MASSDOT DESIGN JUSTIFICATION WORKBOOK

SPRINGFIELD - MCKNIGHT COMMUNITY TRAIL

PROJECT 608157

16-Jul-21

TYPICAL SECTIONS

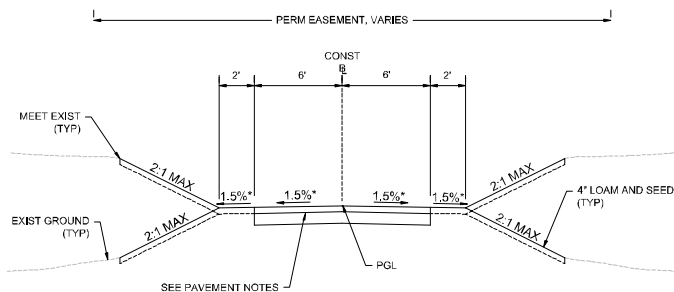
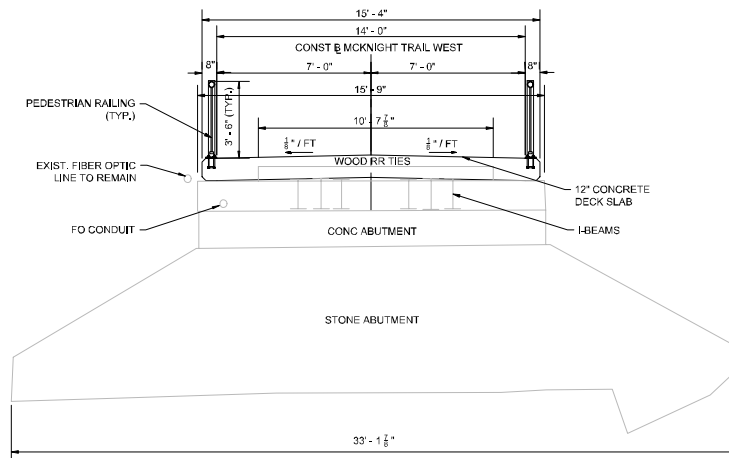
the bicycle accommodation criteria applies to this project and is not met due to the 6' and 8' proposed width.

Path users will have to use a short section of sidewalk along Bay Street that is only 6' wide.
